## Product Change Notice (PCN)

**PCN Number:** PCN-0450994R-01

SJ1-3553NG, SJ1-3554NG, SJ1-3555NG, & SJ1-3555NG-BE

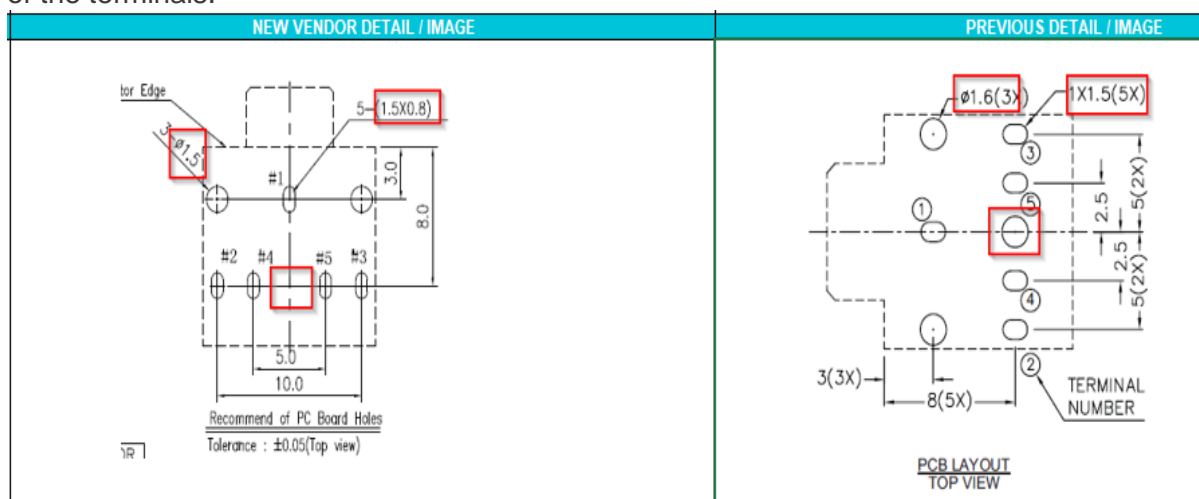
1. PCB hole recommendation differs, image does not have location feature in the back row of the terminals.

2. Terminals, and housing materials have changed
